LAND USE APPLICATION

Other: Modification

NARRATIVE & COMPLIANCE REPORT

Sunset View at West Banks: Minor Modification

PRELIMINARY PLAT
(PHASE 1)

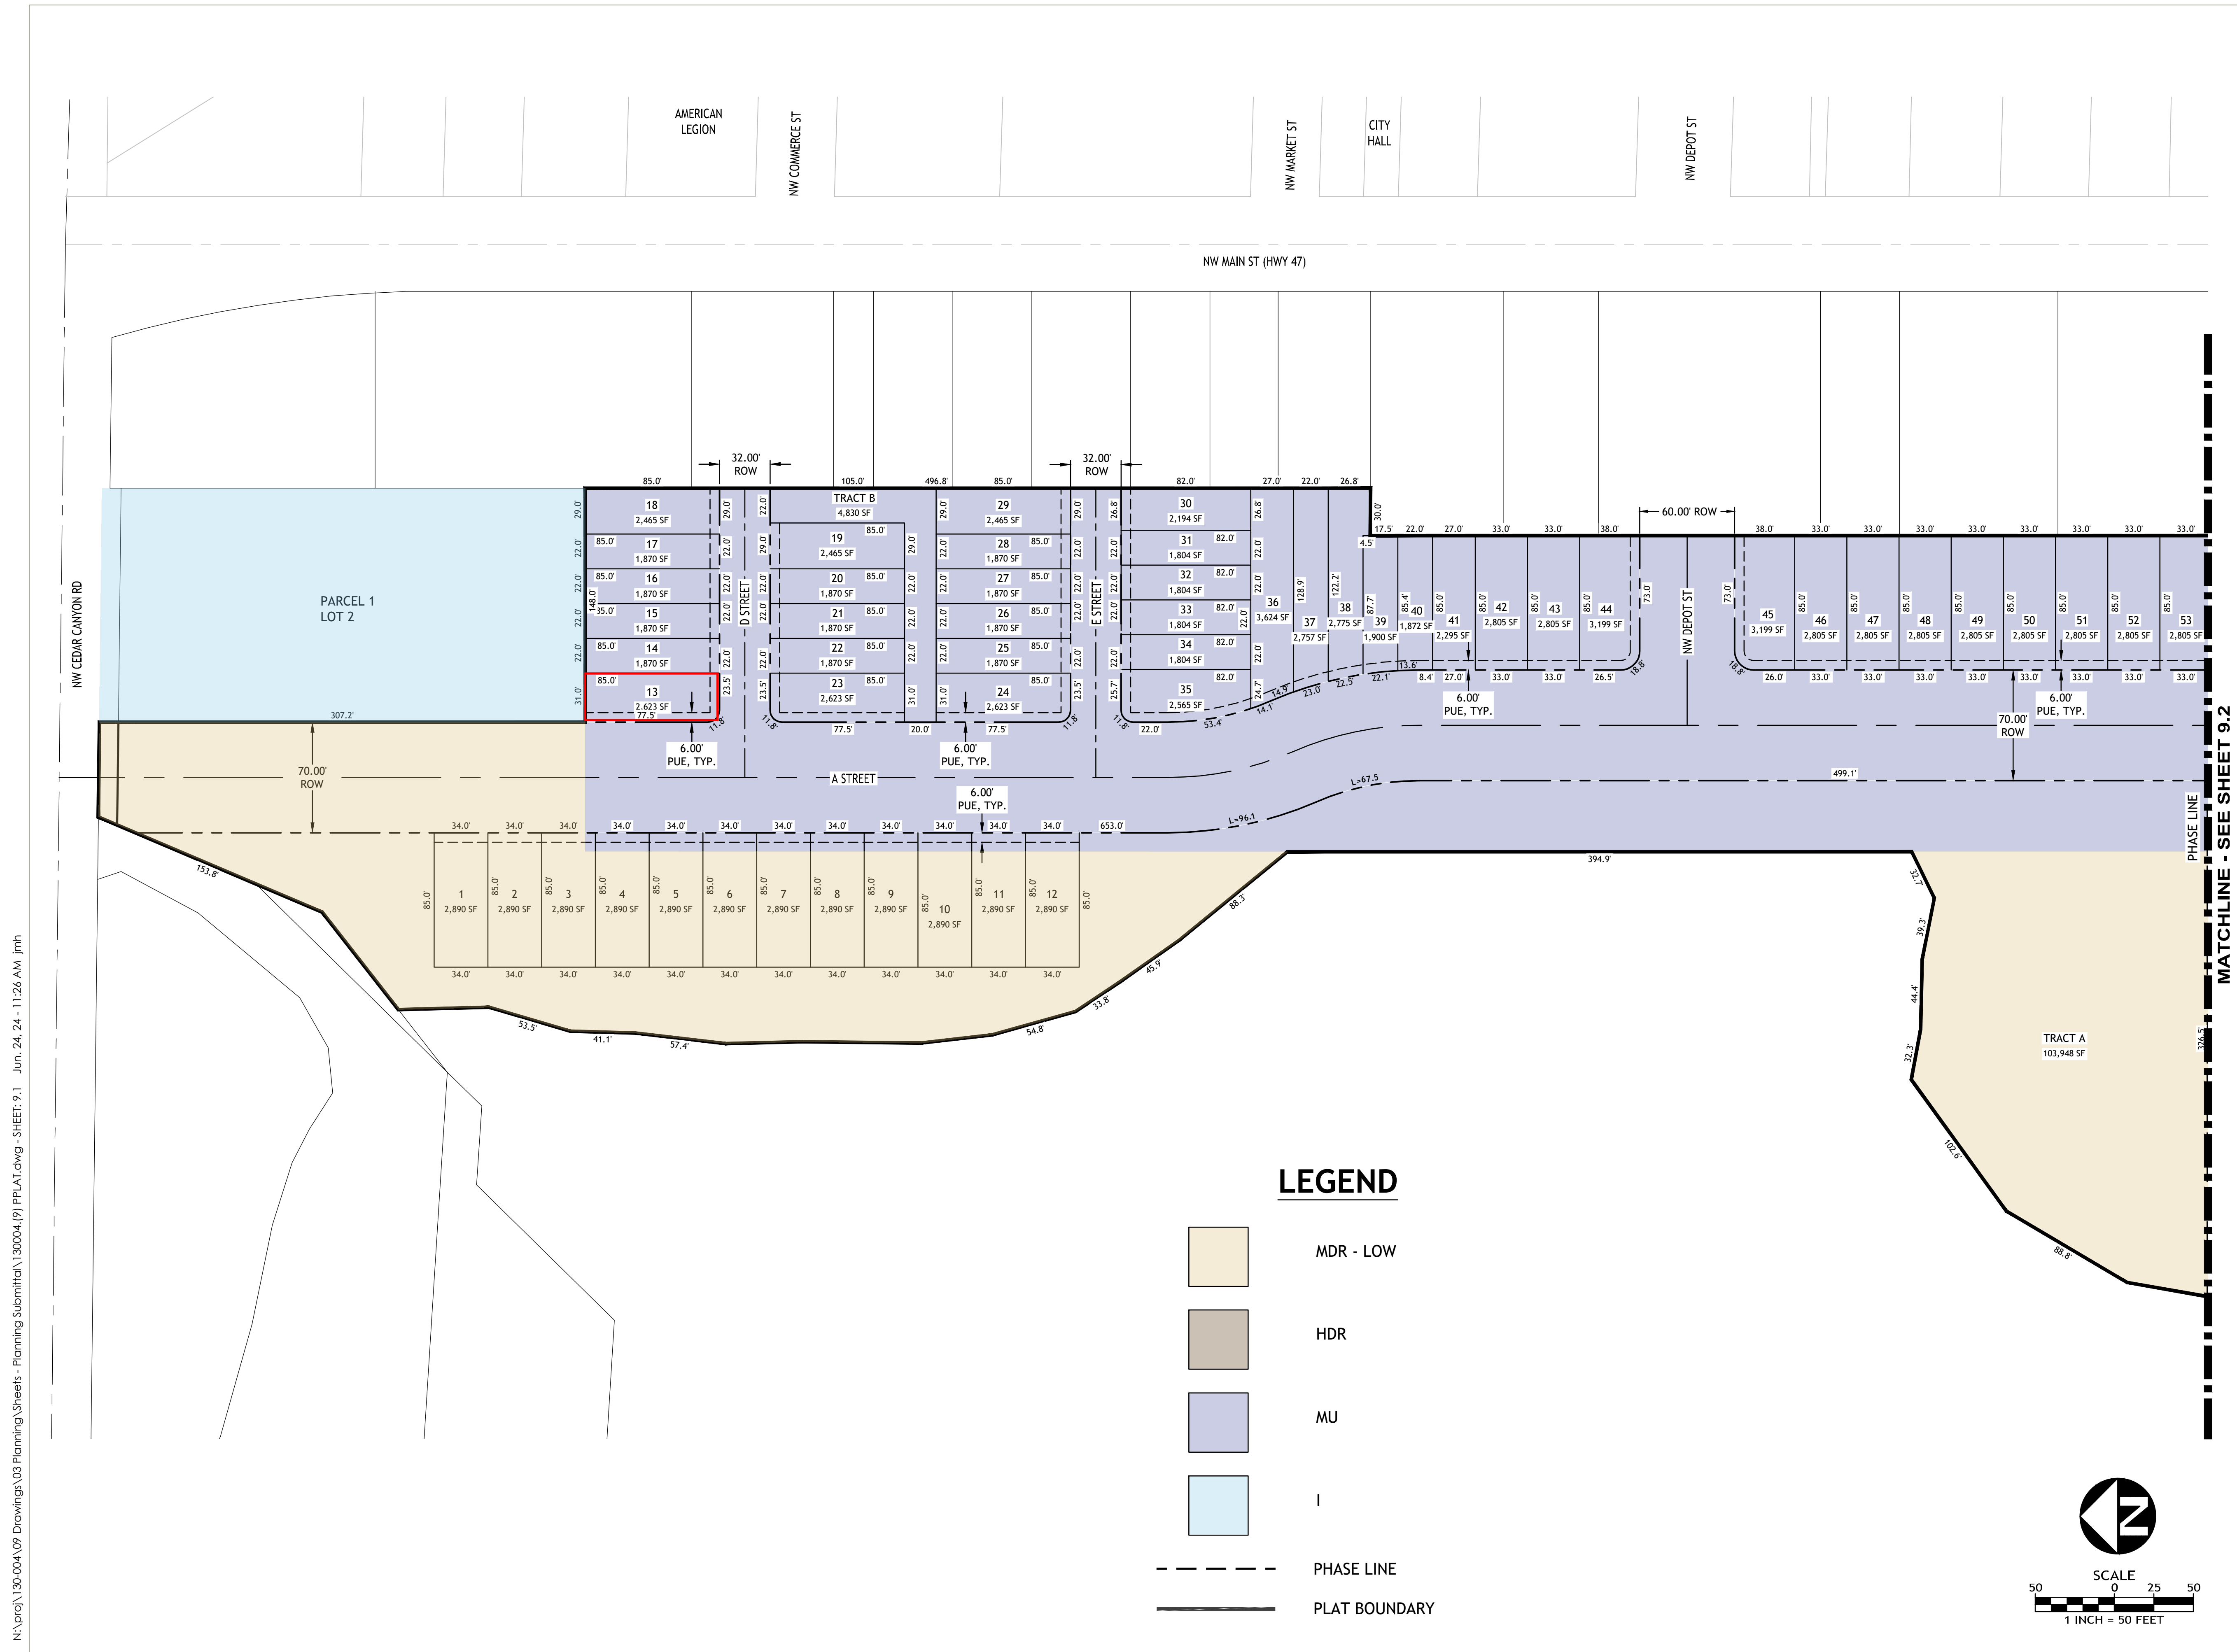
Response: The applicant is requesting a change to certain townhome corner lots throughout the Sunset View development. This is a 2 ft decrease in minimum lot width from 30 ft to 28 ft. This is a 7% difference in width change which falls within the threshold of Minor Modifications. The city has also requested that the removal of Tract E be included in this minor modification, as it does not meet the thresholds of the Major Modification. These changes are indicated on the plat sheets included in Exhibit B.

- Minimum Townhome Corner Lot Width in the Mixed Use and High Density Residential- originally modified from 40 ft to 30 ft, now requesting 28 ft. This is within the 20% threshold for a minor modification.

PRELIMINARY PLAT
(PHASE 2 & 3)

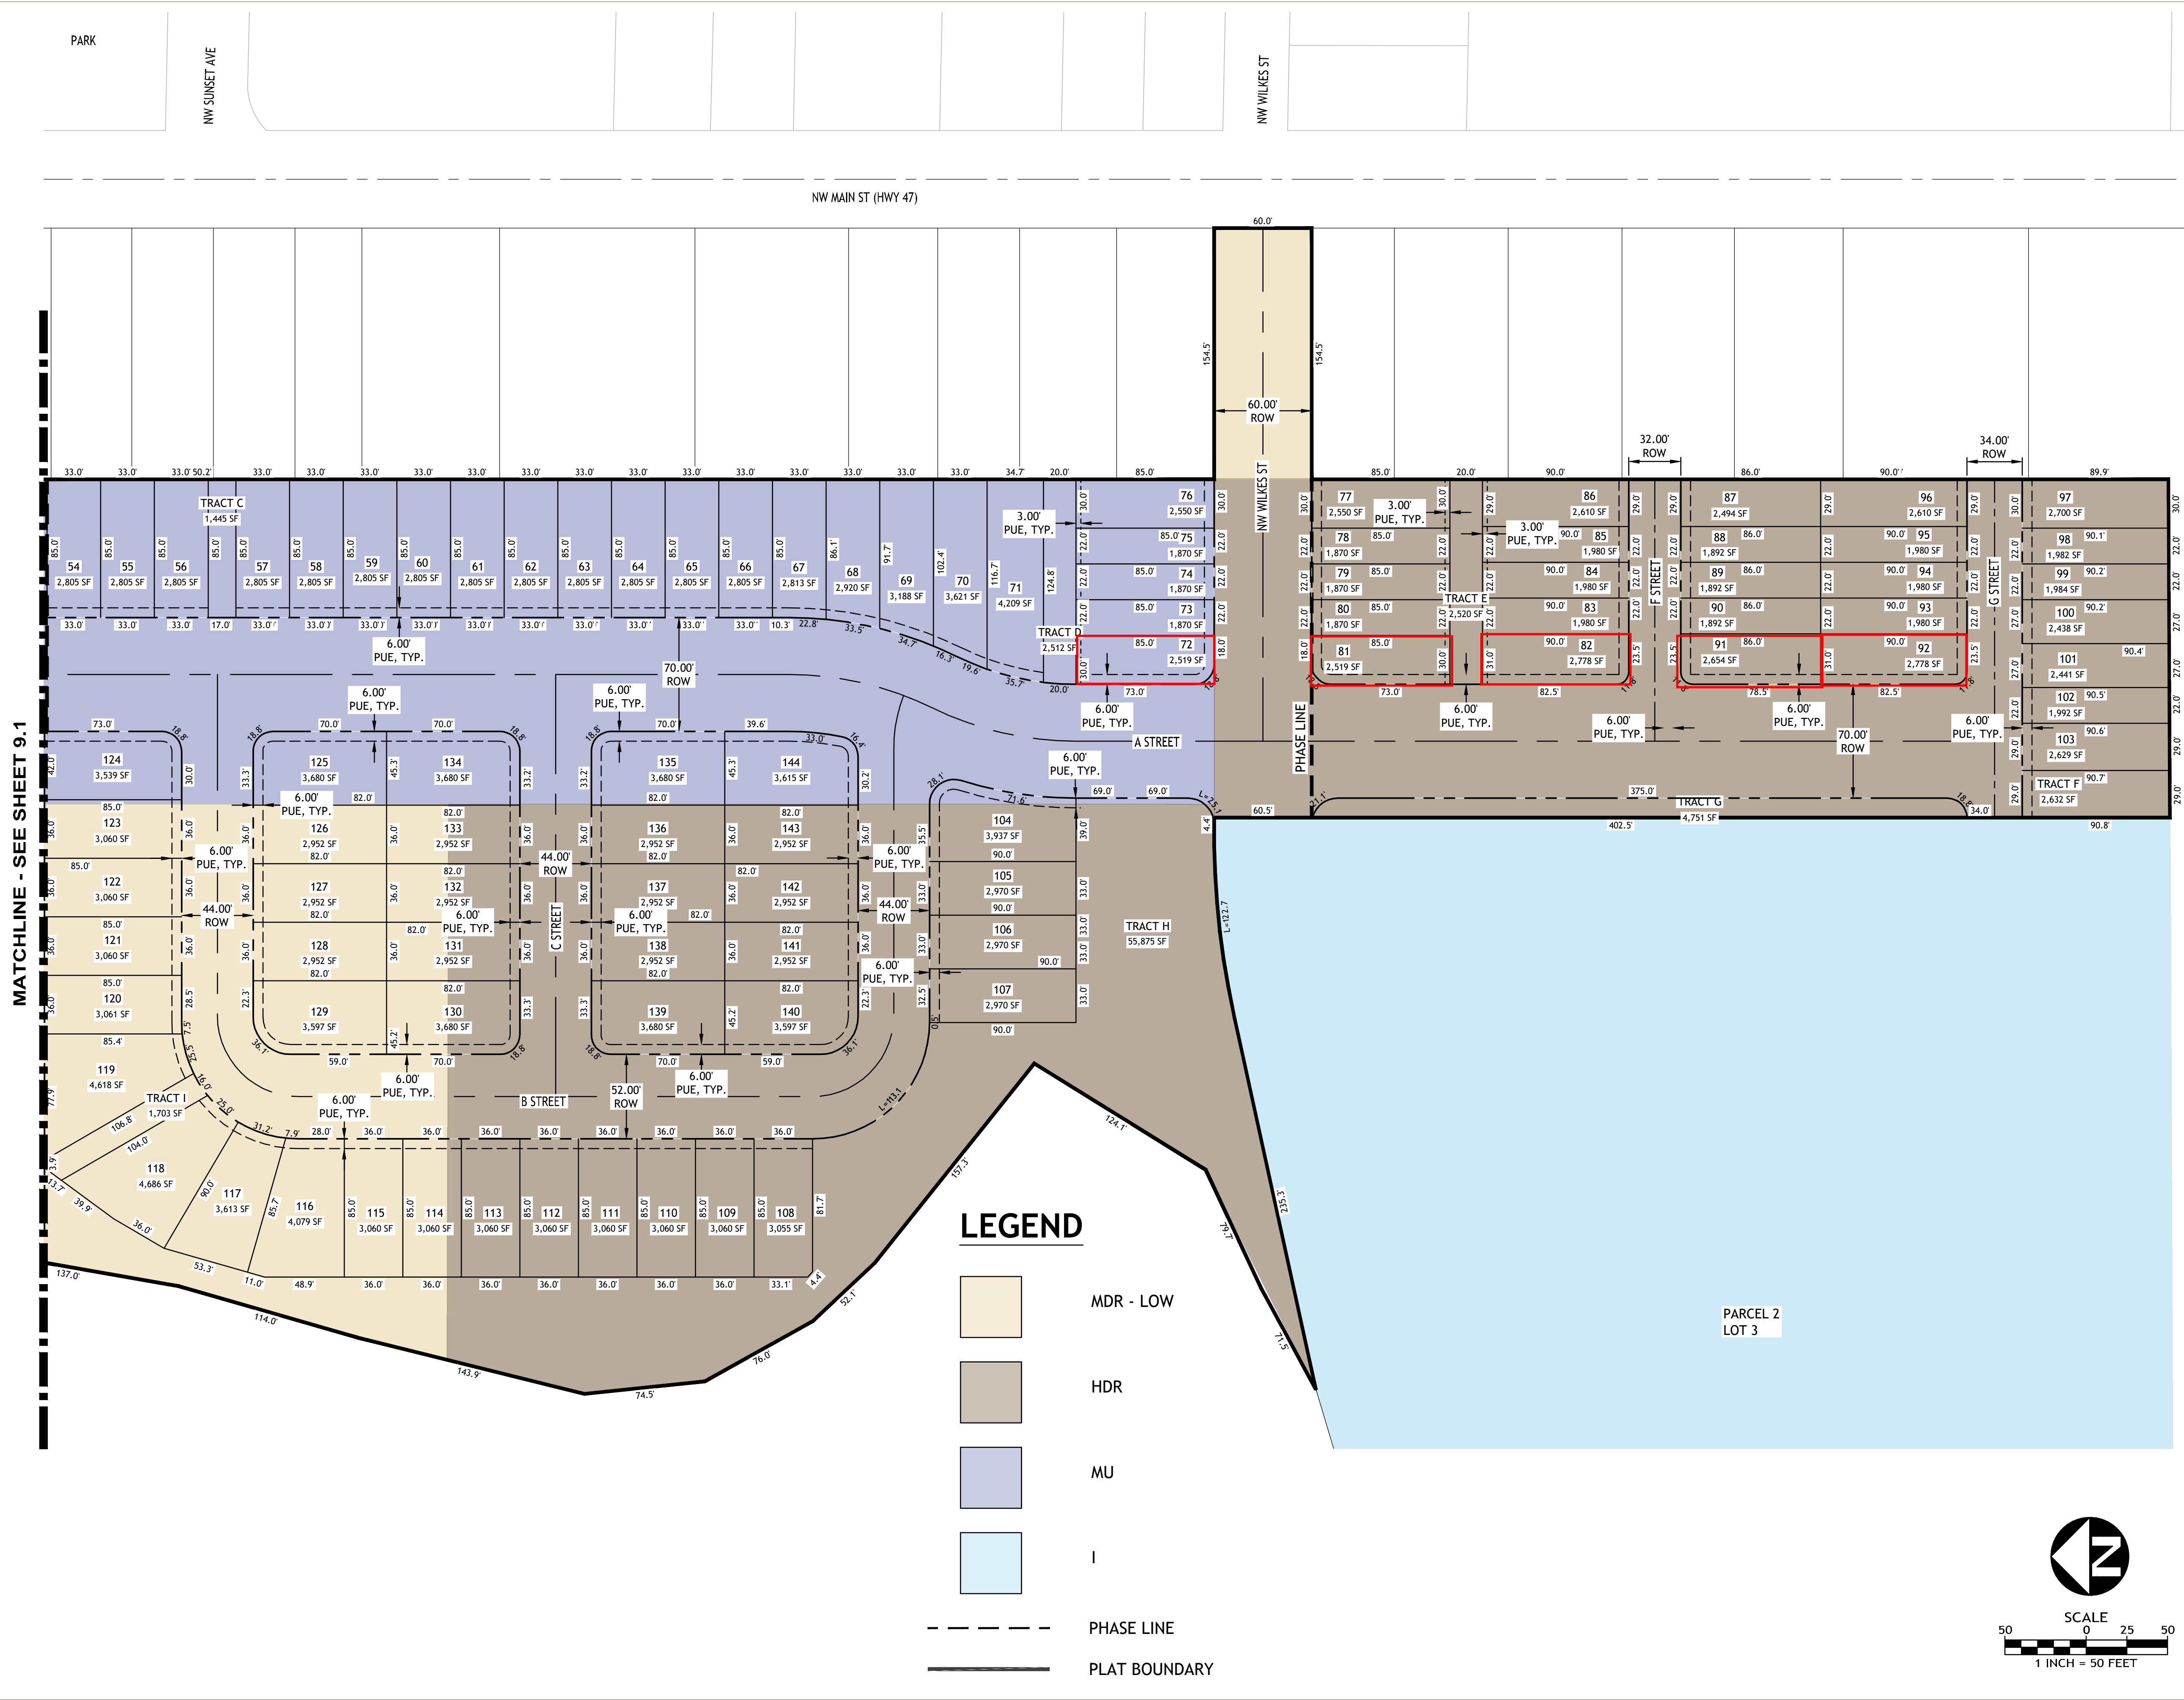
Also included with this Minor Modification application is the removal of Tract E, between lots 56 and 57. The city requested on March 13th that this tract, which held a pedestrian path, be removed. This was originally Tract C in the Master Planned Development application. The Tract E area has been absorbed and distributed to lots 56 and 57. Sheet 2 in Exhibit B details the tract removal and lot size changes due to this requested change.

Response: The removal of the Tract E pedestrian path creates a block size that exceeds the maximum block length. However, the City has requested that this tract be removed as the off-site pedestrian path that it was planned to connect with is not able to be developed due to existing land use. As such, if Tract E was to remain without the off-site extension, it would have a dead-end and create a space with the potential for nuisance use and behavior not desired by the city and development.

Response: The city has requested that Tract E, between lots 56 and 57, be removed and the tract area be absorbed and distributed between the two lots. Therefore, this condition is no longer applicable.
